Power Back Door System Has Abnormal Closing Operation

Applicability

| YEAR(S) | MODEL(S) | ADDITIONAL INFORMATION |
|-------------|---------------------------|------------------------|
| 2008 - 2013 | Highlander, Highlander HV | |

Figure 1.

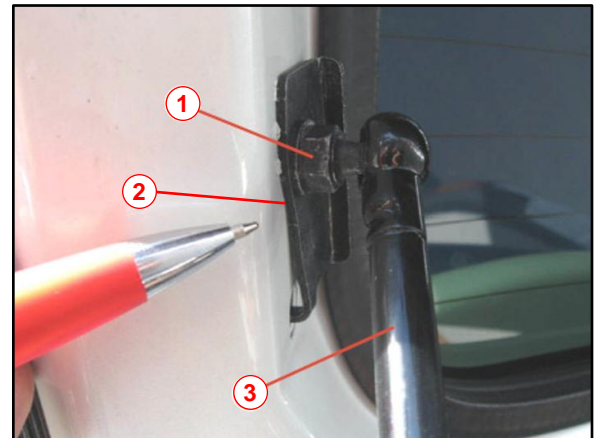
1. Visually inspect the Lift Arm Stud and Power Back Door Bracket for bends or damage.

Are the Power Back Door Bracket and Lift Arm Stud damaged?

- **YES** — Go to the Repair Procedure.
- **NO** — Continue to step 2.
